STAFF RECOMMENDATION
3921 Kimpalong Avenue
October 16, 2019

Application: New Construction—Detached Accessory Dwelling Unit (DADU)
District: Woodlawn West Neighborhood Conservation Zoning Overlay
Council District: 24
Base Zoning: R10
Map and Parcel Number: 10316008400
Applicant: Tyler LeMarinel, Allard Ward Architects
Project Lead: Paul Hoffman; paul.hoffman@nashville.gov

Description of Project: This application is for construction of a new outbuilding/detached accessory dwelling unit (DADU). The applicant requests a right-side setback determination from five feet (5') to three feet (3'). **Recommendation Summary:** Staff recommends approval of the application with the conditions: **1.** The right-side setback is increased to five feet (5'); **2.** Staff approve the final details, dimensions and materials of roofing color, windows, doors and garage doors prior to purchase and installation. With these conditions, the proposed outbuilding/detached accessory dwelling unit (DADU) will meet Section II.B for new construction of the Woodlawn West Neighborhood Conservation Zoning Overlay. The Commission does not have the authority to approve the use. This recommendation is for the design

1 Site Layout Plan

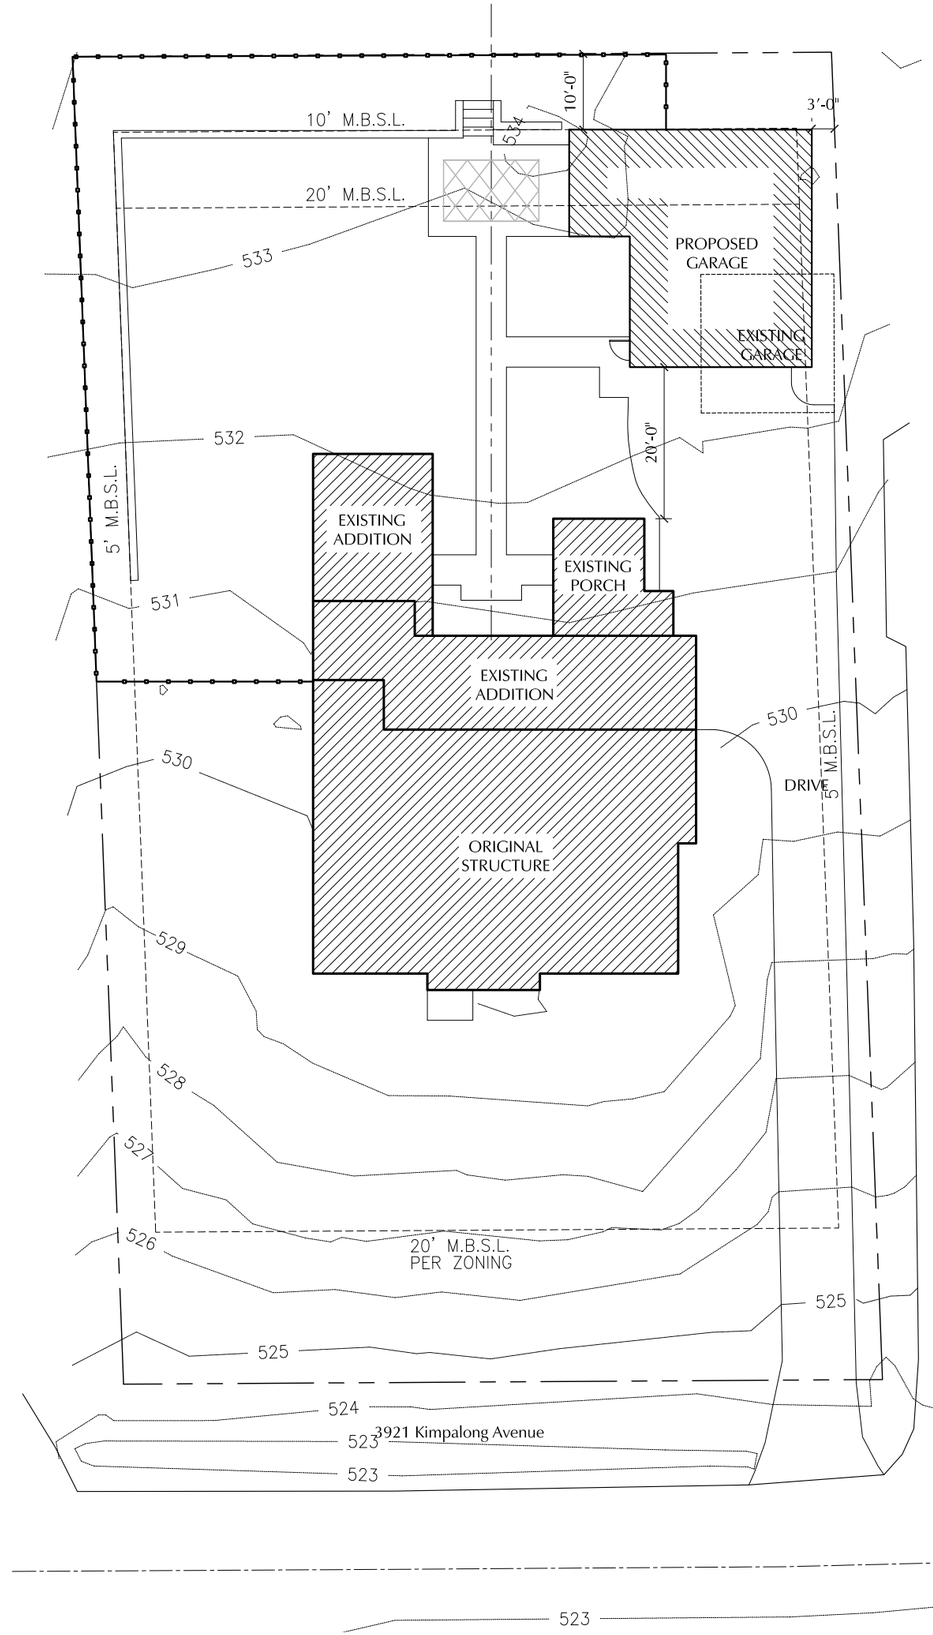
The outbuilding will be located at the rear of the lot and will be accessed via the existing driveway. There is no alley. The power lines running across the rear property line of this block have an overall twenty-foot (20’) easement, ten feet (10’) on each neighboring rear yards. The outbuilding has proposed setbacks of ten feet (10’) at the rear, sixty-five feet (65’) from the left side property line, and three feet (3’) from the

right-side property line. The applicant requests a setback determination of three feet (3') for the right side. The Commission has not approved a reduced side setback for an outbuilding or DADU in most cases and has kept to five feet (5') setback to follow base zoning. Staff therefore recommends that the side setback is increased to five feet (5') to meet these requirements.

1. The right-side setback is increased to five feet (5');
2. Staff approve the final details, dimensions and materials of roofing color, windows, doors and garage doors prior to purchase and installation.
